## **REQUEST FOR VARIATION TO THE PROPOSED BROWSE TO NWS PROJECT (EPA ASSESSMENT NUMBER 2191)**

Woodside Energy Ltd (Woodside), as Operator for and on behalf of the Browse Joint Venture (Woodside Browse Pty Ltd, BP Developments Australia Pty Ltd (BP), Japan Australia LNG Ltd (MIMI Browse Pty Ltd) and PetroChina International Investment (Australia) Pty Ltd (PetroChina)) referred the State Proposal component of the proposed Browse to NWS Development to the Environmental Protection Authority (EPA) in October 2018 (EPA Assessment Number 2191).

The State component of the Proposed Browse to NWS Development (the Proposal) is currently being assessed as a Public Environmental Review under the *Environmental Protection Act 1986* (EP Act). In light of engagements and guidance from the EPA, Woodside seeks to amend the Proposal, in accordance with section 43A of the EP Act, to reflect a number of refinements that have been made subsequent to the publication of Response to Submissions on the Environment Review Document in September 2022. Each of the five requested amendments are expected to result in lower risk or impact to the Western Australian environment.

**Figure 1 Proposed updated Browse development envelope (yellow) in WA State waters**

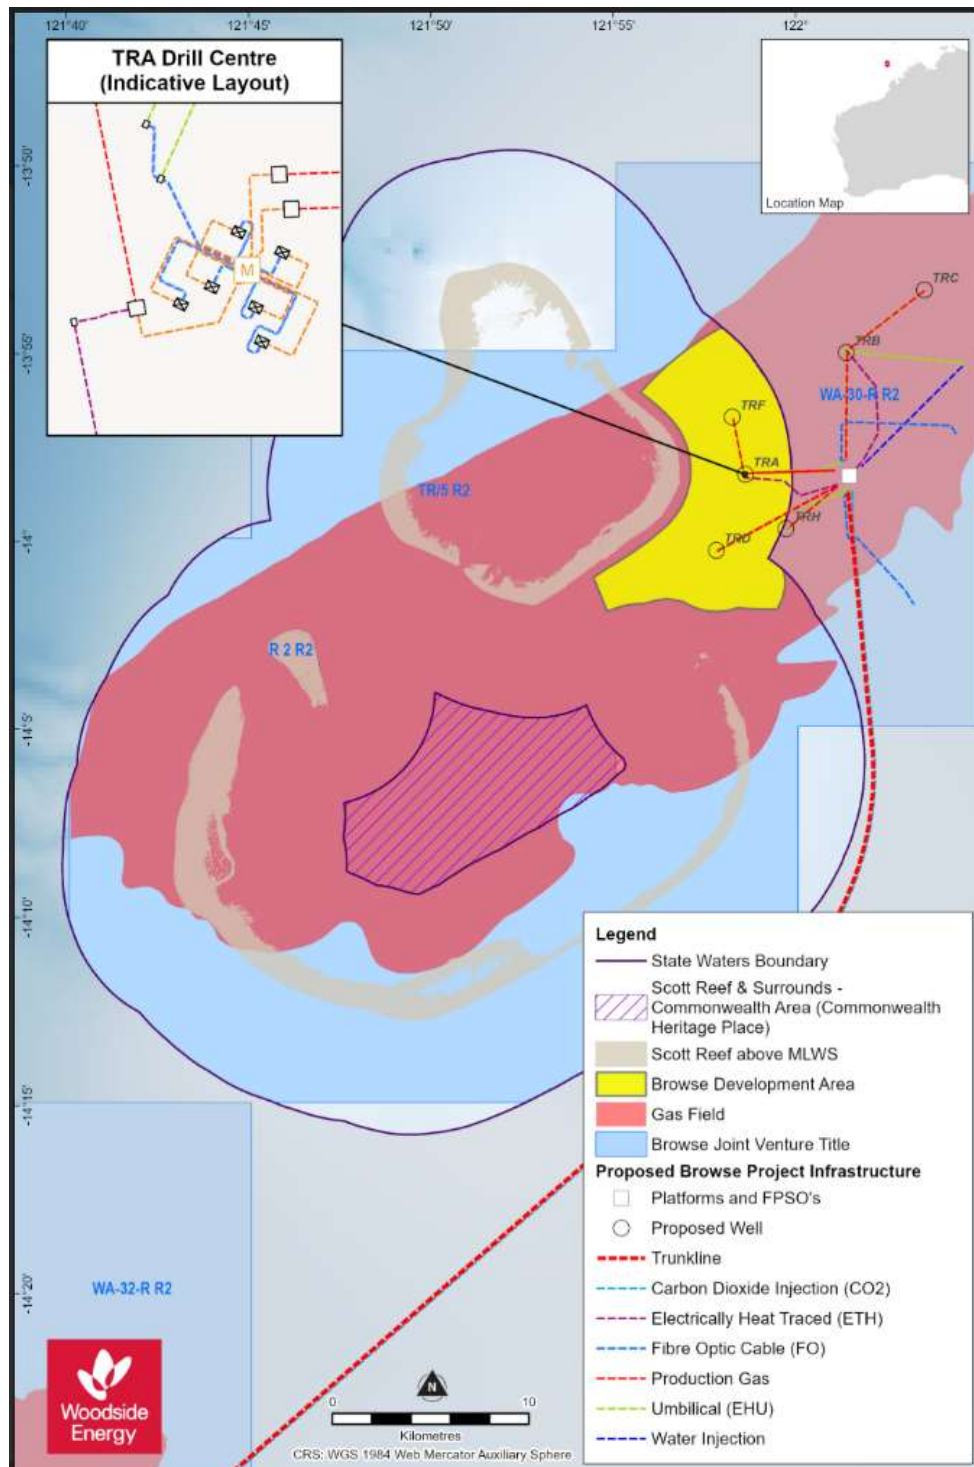
### **1. Revising (reducing) the size of the proposal's development envelope**

The development envelope (DE) is defined in EPA guidance as the maximum area within which the proposal footprint, including all physical elements, will be located. Upon referral, the DE for the Proposal within State waters was aligned with the marine boundaries of Petroleum Retention leases (WA-30-R R2 & TR5 R2) associated with the proposal. This covers an area around 1,220 km<sup>2</sup> and overlaps Scott Reef shallow water benthic habitats and Sandy Islet.

Woodside is proposing to reduce the DE to only include the location of proposed physical infrastructure or permanent seabed disturbance, including relevant buffer zones for temporary disturbance during construction activities such as anchor and pipeline installation. This revised DE has a total area of 78 km<sup>2</sup> as shown in Figure 1. There is no change to the area of direct or indirect seabed disturbance estimates, as currently reflected in the Proposal Content Document.

This DE revision also takes into account the reduction in spatial extent of proposed activities and seeks to provide improved transparency and certainty as to the maximum authorised extent of the location of activities associated with the Proposal. The proposed reduction in the DE means that it no longer overlaps the Scott Reef shallow water benthic habitats or Sandy Islet. This revised DE aligns with EPA's contemporary guidelines and expectations.

**Figure 2 Proposed TRD drill center relocation relative to the Habitat Critical to the Survival of Green Turtles interesting buffer**

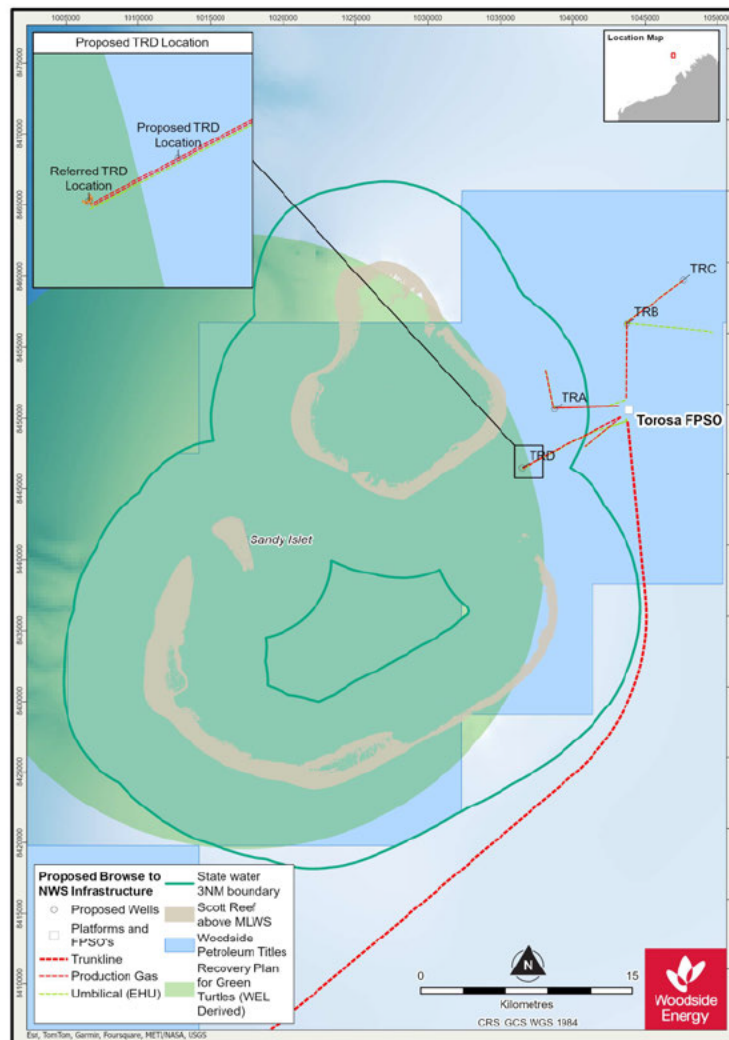
## **2. Relocate the TRD drill centre outside of habitat Critical to the Survival of Green Turtles**

The proposal involves drilling up to 20 wells, each of which will be located within around 500 m of three drill centres (TRA, TRD and TRF).

To minimise risk and impacts to Green Turtles, the 'TRD' drill centre is being re-located east, further away from Sandy Islet which is a known nesting location for Green Turtles. The updated coordinates for drill centres in

State Waters are presented in Table 1. If approved, no drilling activities as part of the Proposal will occur within 20 km from Sandy Islet. This area is classified as an interesting area 'habitat critical to the survival of green turtles' as defined in the Recovery Plan for Marine Turtles in Australia (Figure 2).

Field	Drill centre in State Waters	Coordinates as of Oct 2022	Proposed new coordinates
Torosa	TRA	389 521 E, 8 455 338 N	No change
Torosa	TRD	387 315 E, 8 451 207 N	388 108 E, 8 451 598 N
Torosa	TRF	388 865 E, 8 458 144 N	No change

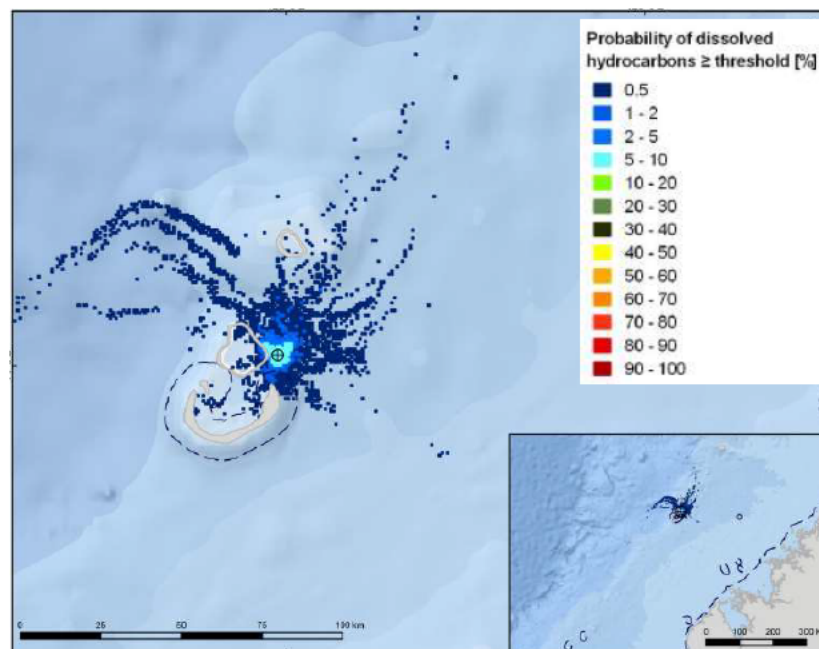
Dissolved hydrocarbons are also relevant for assessing potential impacts to the shallower water benthic habitats of Scott Reef. The modelling indicated that there is a low likelihood (10.5% probability) that dissolved oil will contact Scott Reef above ecological thresholds of 50 ppb<sup>2</sup>. For the small areas of Scott Reef that may be contacted, the likelihood of dissolved oil contacting above the ecological threshold ranges from <0.5% to 5%. Figure 3 has been extracted from the attached spill modelling report as an example.

The maximum concentration of dissolved hydrocarbons in the worst-case simulation was 247 ppb at Scott Reef North and 124 ppb at Scott Reef South. This is slightly higher than the ecological impact threshold of 50 ppb<sup>2</sup>. The modelling results suggest that in the highly unlikely event of this scenario, impacts are likely to be restricted to the most sensitive species or life stages of these habitat and communities.
